ADDENDUM NO. 3

SANTA MARGARITA WATER TREATMENT FACILITY PROJECT

This Addendum (including attachments), dated September 13, 2019, includes 56 pages.

**C3**

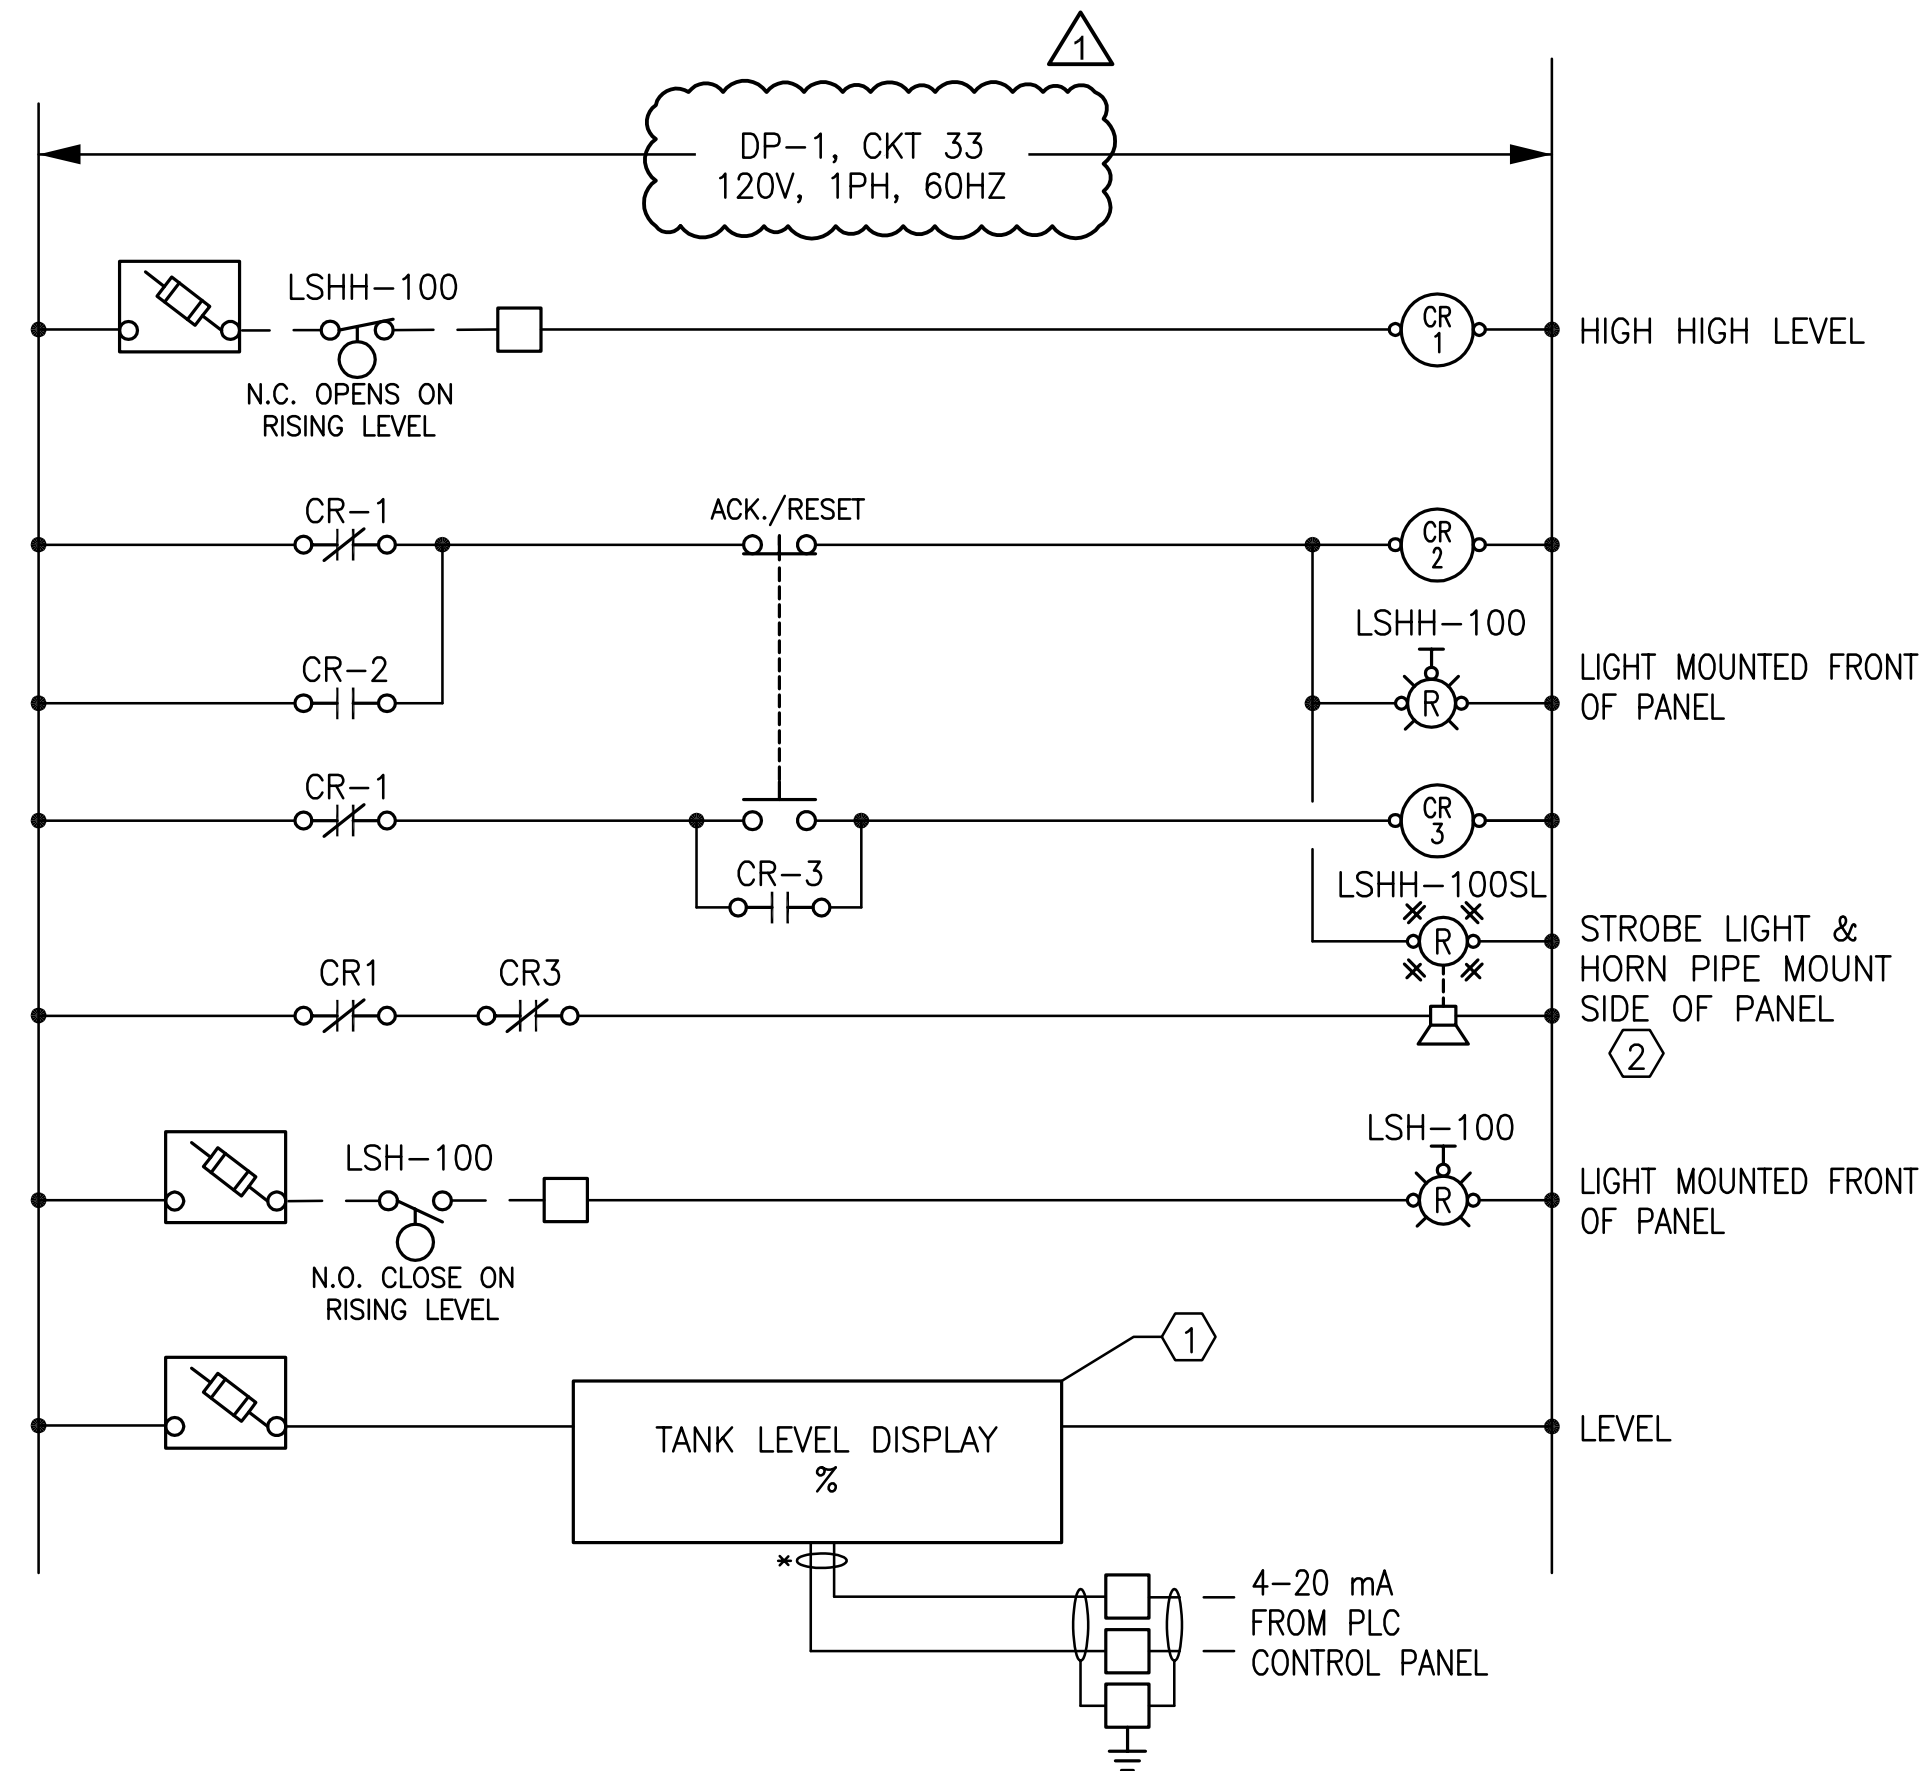
Please provide clarification on the A/C pavement for the project. On pg. C3, note #6, calls for new A/C pavement and to refer to note 14 sheet C1. Note 14 gives direction when replacing existing A/C pavement from trenching and calls for ¾" medium mix. Note 11 calls for Type B, ½".

Which mix design is required?

What is the thickness of the new A/C pavement section?

Note #11 governs for the A.C. pavement. Note #14 is for the work on GJM.

Using the flexible pavement design contained in Caltrans Highway Design Manual, with a Traffic Index of 5 and an assumed R-value of 30 the structural section should be 4" of Type A Hot Mix Asphalt (1½" Aggregate Gradations) over 8" of Class 2 Aggregate Base (¾" maximum Aggregate Gradation). Please be advised that the R-value is assumed as noted and I recommend an R-value of the subgrade soil be performed by the soils engineer to determine the actual thickness of Class 2 Aggregate Base and Type A Hot Mix Asphalt required.
